Vernon-Sicilian House & 21 Southampton Row

Conservation Officer Comments - HBA Response
December 2022

This document has been prepared in order to address some of the comments received by the London Borough of Camden's Conservation and Heritage team on 9 November, 2022, regarding the proposed refurbishment works to Vernon and Sicilian House and 21 Southampton Row, which constitute Project 1 of the Holborn Links Estate.

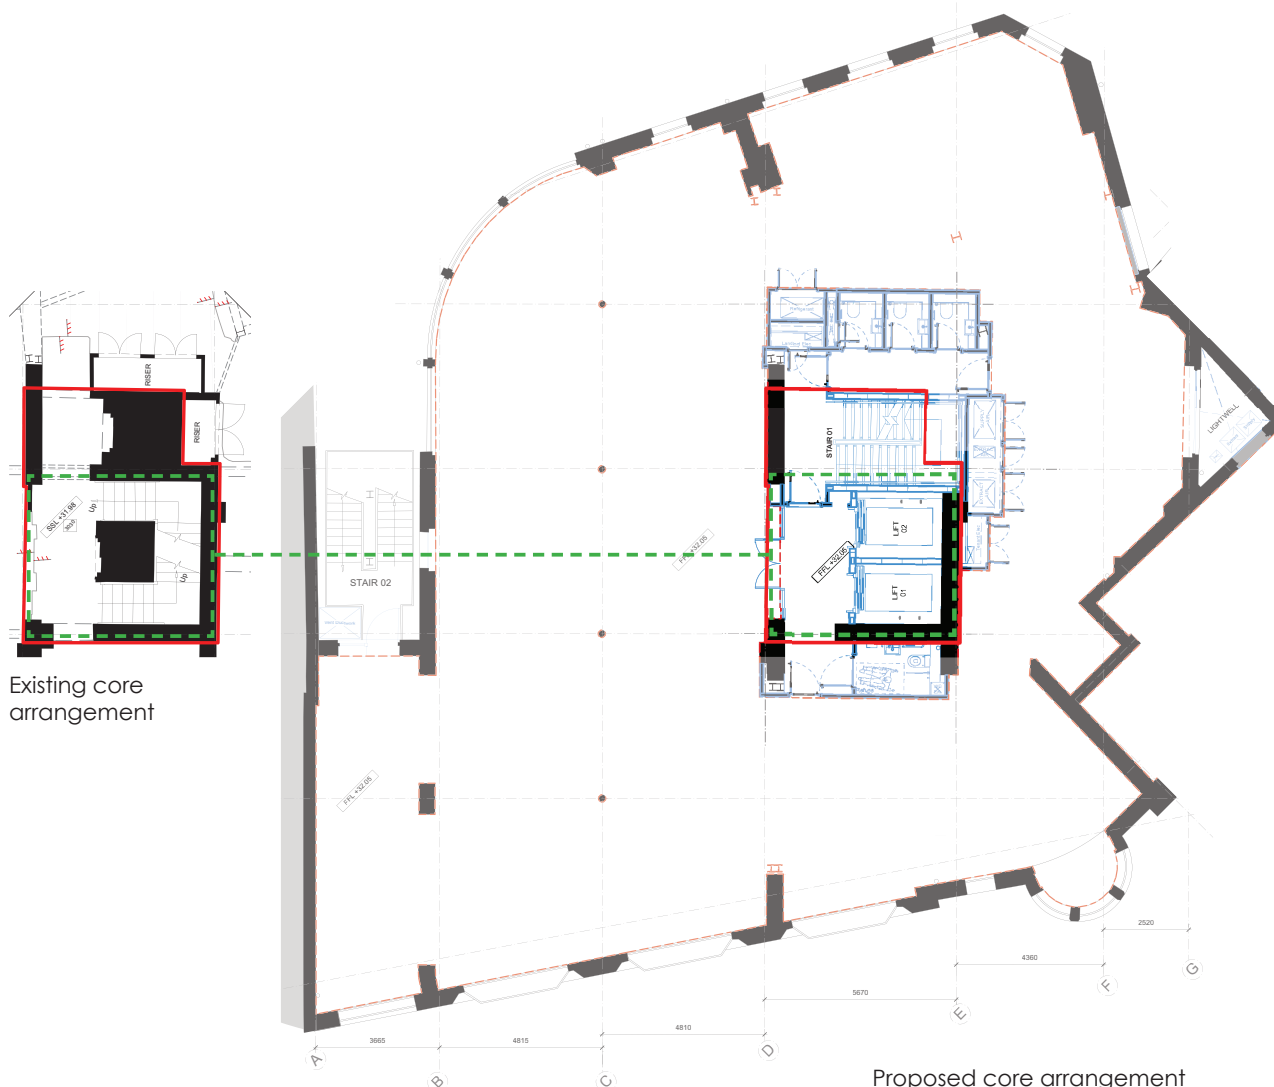
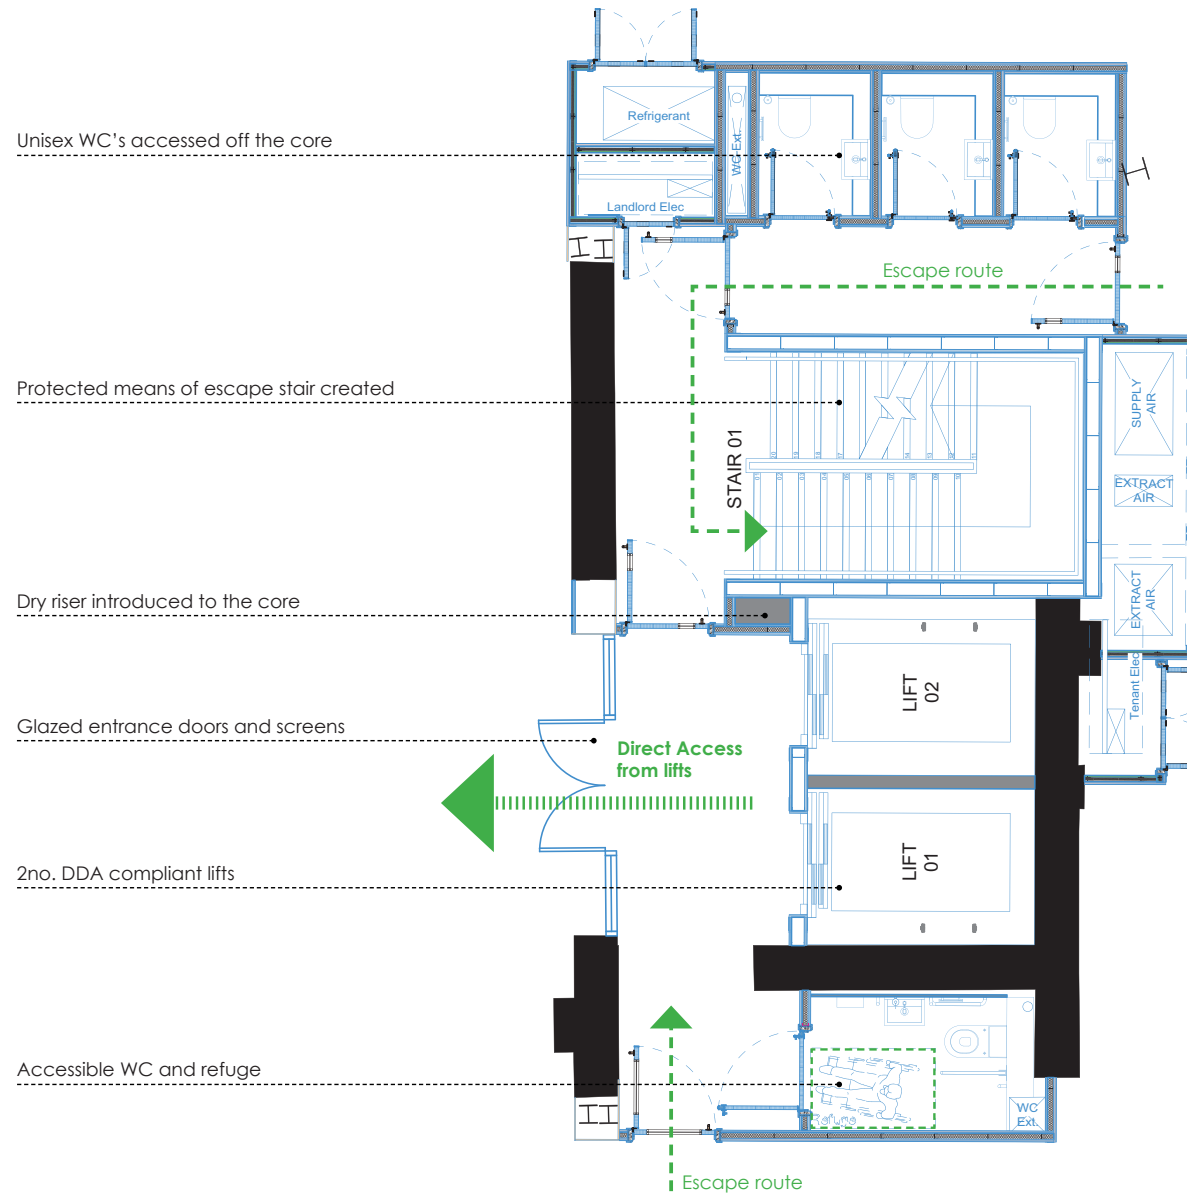
**'In 21 Southampton Row, the primary staircase should remain
in its original position.'**

- Retention of the existing stair and lift arrangement was extensively explored by the design team however, all options resulted in either compromised access routes into the offices, or significant loss of office floor area which impacted the viability of the refurbishment

- As the structural integrity of the existing stair is questionable and it cannot provide a landing with level access to the office floors it has to be completely replaced

- Both lifts also need to be completely replaced due to their age and condition, with the lift in the centre of the stairs also requiring a new shaft
- Due to the level of refurbishment works that are required reconfiguring the core's layout while retaining its central location is considered reasonable

- The reconfigured layout would offer direct access into the offices via glazed doors providing a great first impression and views of the improved office floor plates, similar to the historic arrangement.

- Undertaken as part of the extensive historic alterations a second DDA compliant lift was constructed adjacent to the stair as the central lift could not be DDA compliant due to space restriction created by the stair

- However, due to the existing landing by the stairs not being the same level as the office floors the new lift landing was set at a higher level with a trip hazard step

- With the second internal stair also being demolished and replaced with the current external escape stair, lobbies were still required between the existing core escape stairs and office spaces

- The lobbies that were created were however not compliant with current building regulation standards
- While the lobby next to the new lift did provide level access to the office, it did not have the required clear width between the doors

- The door also swung in the wrong direction for means of escape and did not provide level access to a refuge point within the core
- On the other side the lobby closest to the stairs compromised the escape width of the stairs due to its door swing

- Additionally it had restricted space between door swings with the space also being ramped, making general access tricky and difficult
- Overall the configuration resulted in very compromised access routes into the offices, that created poor first impressions and removed the direct access and uninterrupted views of the open floor plate that the original stair and lift provided

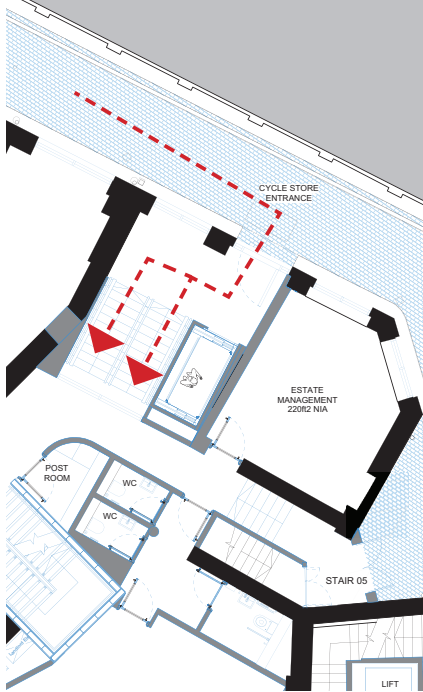
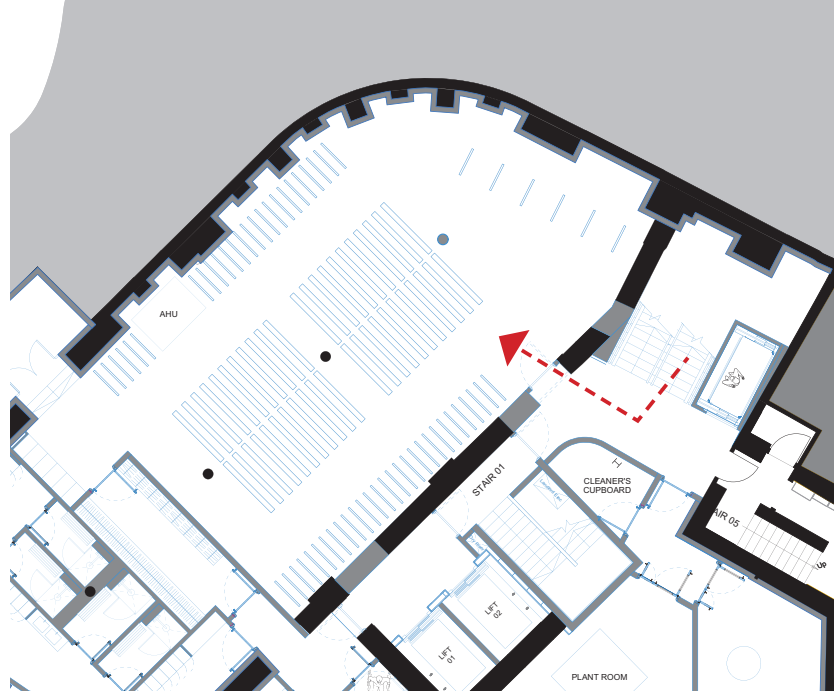
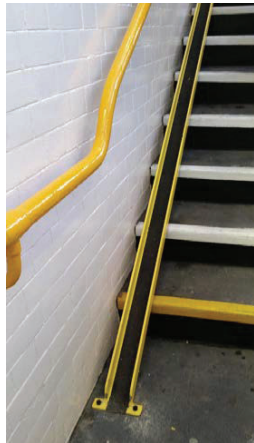
**'In 21 Southampton Row, the bike access should
be limited to a lift only.'**

- For the new bike store and changing facilities to function as a real amenity space for the wider estate it has to be easily accessible
- To reduce the level difference between the entrance and the basement cycle store area down to 1.8m, the entrance door at ground floor has been positioned at the lowest viable part of the rear service yard

- The historic drawings also suggest that there was an access door within that bay
- While the platform lift will provide improved access to the basement storage area, as it is only feasible to install a platform lift, travel times over the 1.8m distance will be relatively slow compared to a conventional traction lift

- At peak times in the morning and evening, if access was limited to just one person using the platform lift, taking into account the 172 people capable of using the amenity space, waiting times would be excessive, resulting in the amenity space becoming impractical to use

- With the inclusion of two wide staircases incorporating side ramps it is understood that access at these busier times would become acceptable and practical

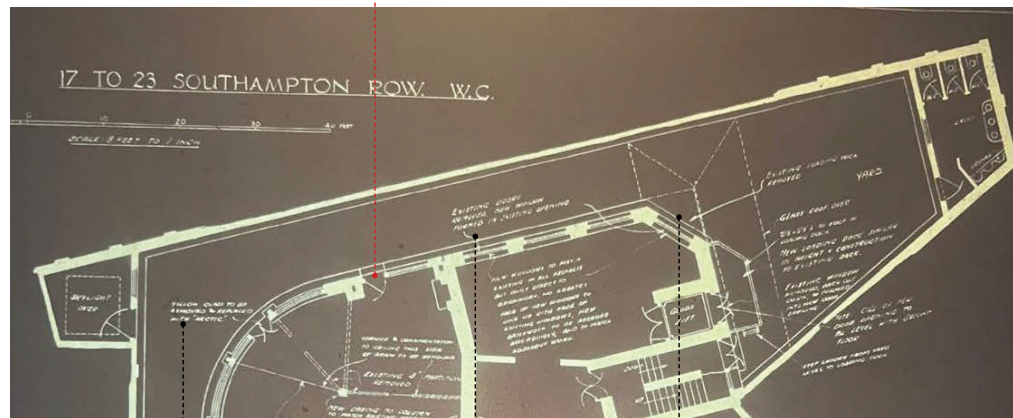
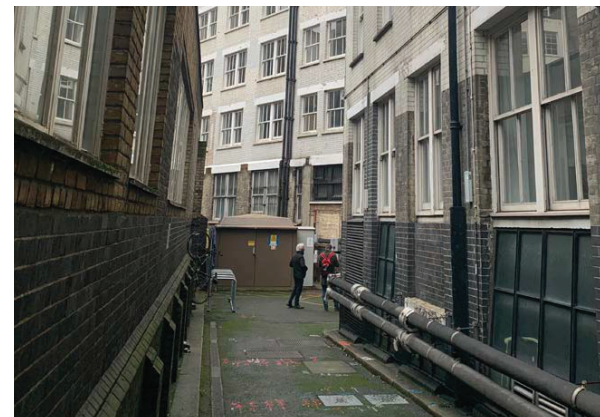
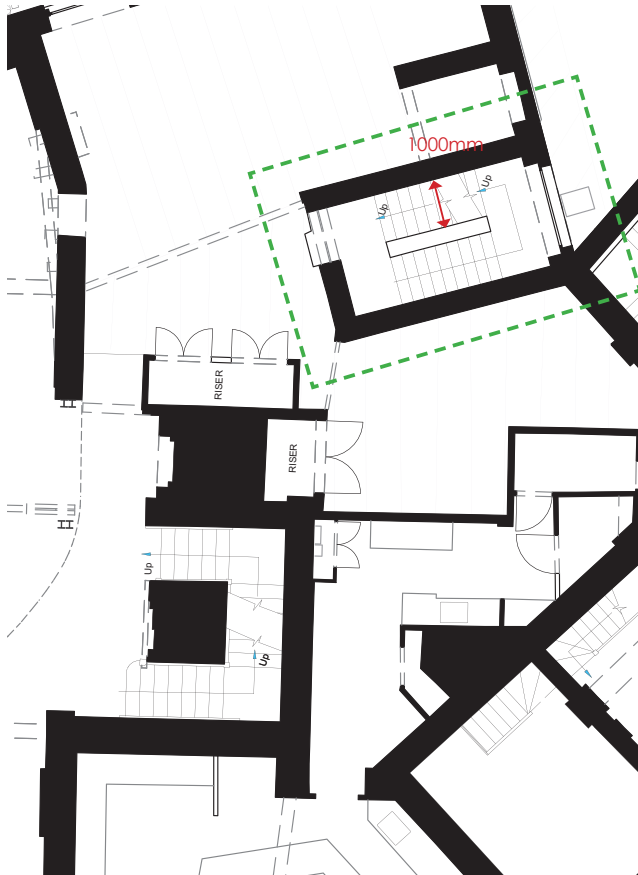
'In 21 Southampton Row, the rear windows should remain as existing.'

- The proposals look to retain the spacing and rhythm of the existing opening in the rear service yard elevation, while improving their appearance to more 'front of house'
- The historic archive floor plans sent to Camden demonstrate that the windows have historically been altered with some converted from windows to doors and visa versa
- As part of the works the existing plant and service runs along this elevation will be removed

Extract from stripped out ground floor plan

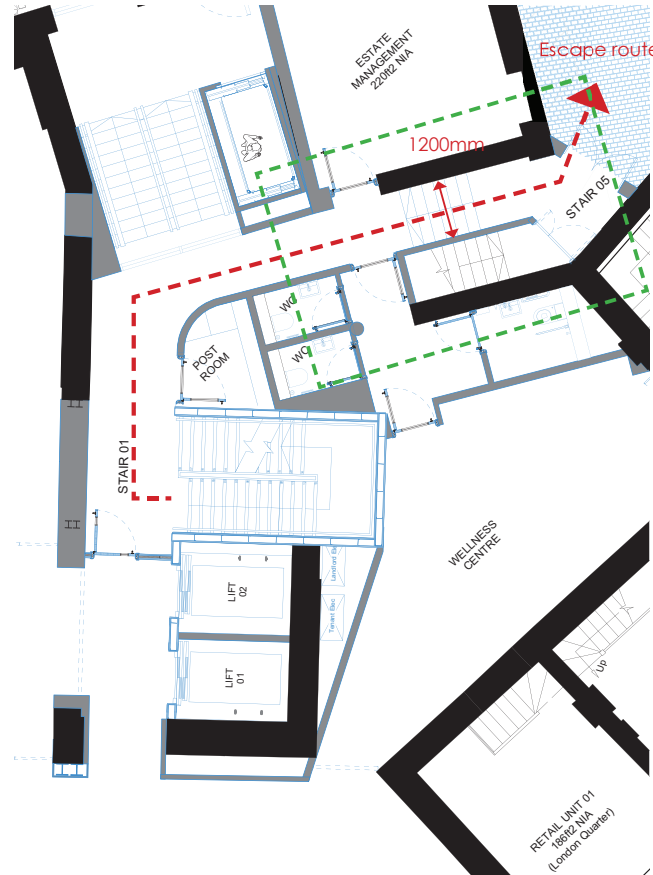
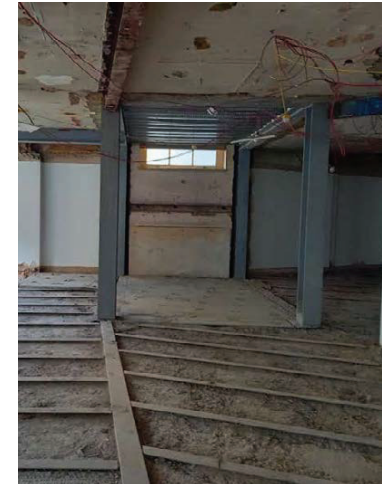
'In 21 Southampton Row, the small staircase leading to rear yard should not increase in width and remain as existing.'

- As part of the reconfiguration of the core at ground floor it is proposed that the final escape exit from the new stair will be via the rear service yard
- In line with the buildings new fire strategy, to maintain a consistent clear width of 1200mm along the escape route the stairs leading to the service yard from ground floor will need to be replaced
- On the upper floors this secondary stair has already been removed as part of the building's previous extensive alterations

Proposed ground floor showing revised wall opening

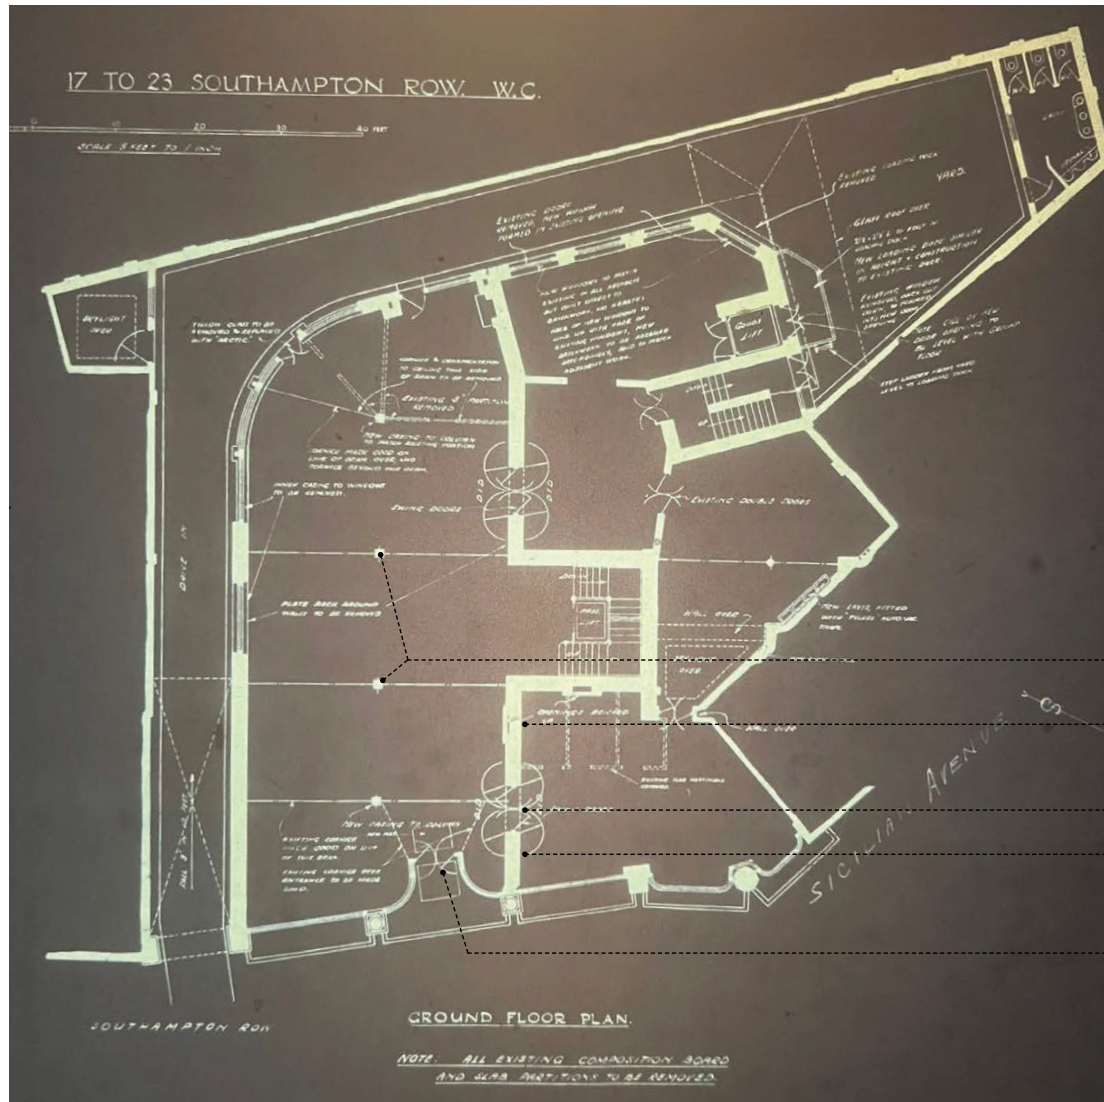
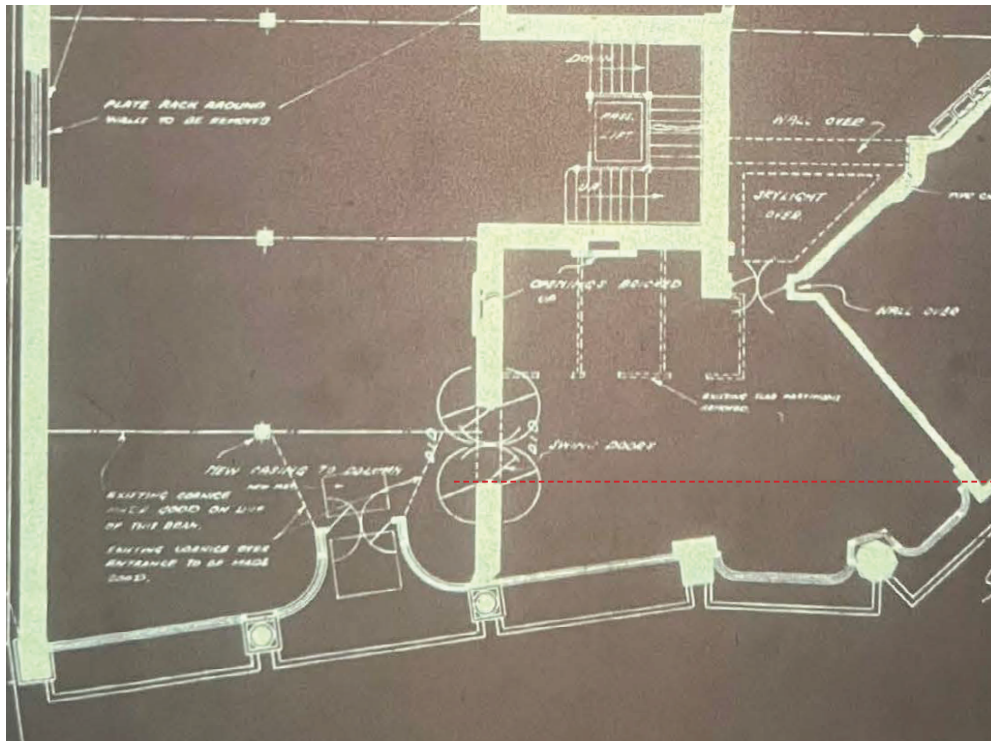
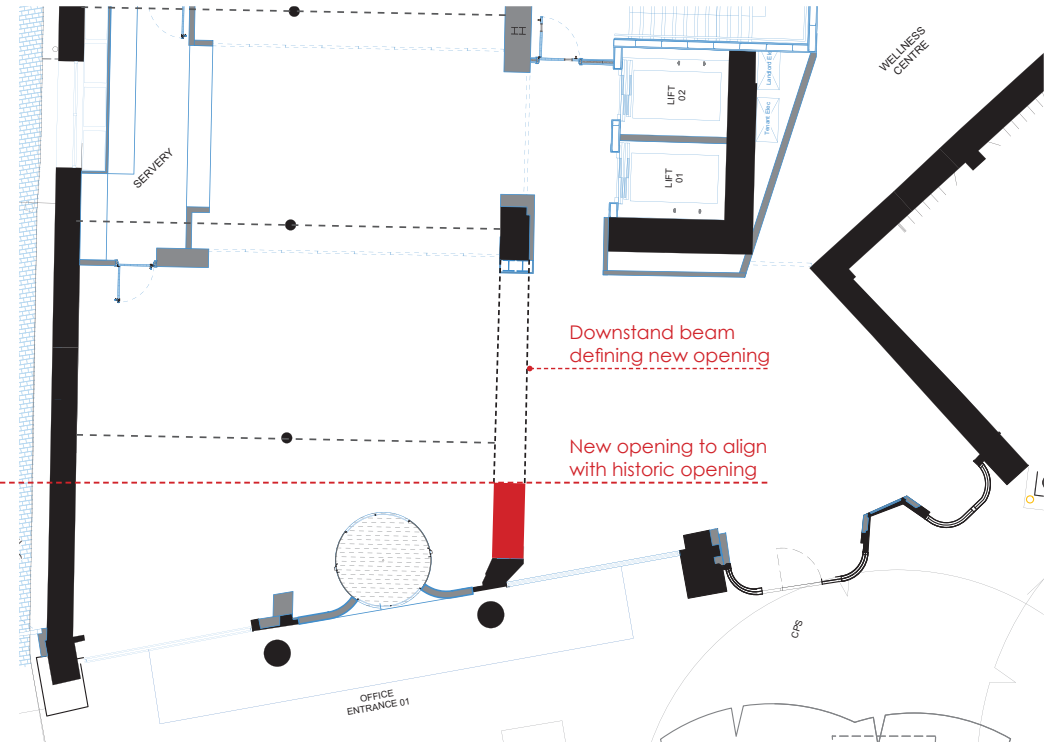
'In 21 Southampton Row, whilst the opening up works in ground floor are now supported, can the opening created to the right of the entrance (which leads to adjacent unit at Sicilian Avenue) be reduced in size and have a legible down stand.'

- At the front of the building the submitted proposals show the removal of most of the separation wall
- From review of the layout and the position of the original opening more of the wall could be retained and its original location defined within the space via a downstand beam
- The revised opening would align with the historic door opening
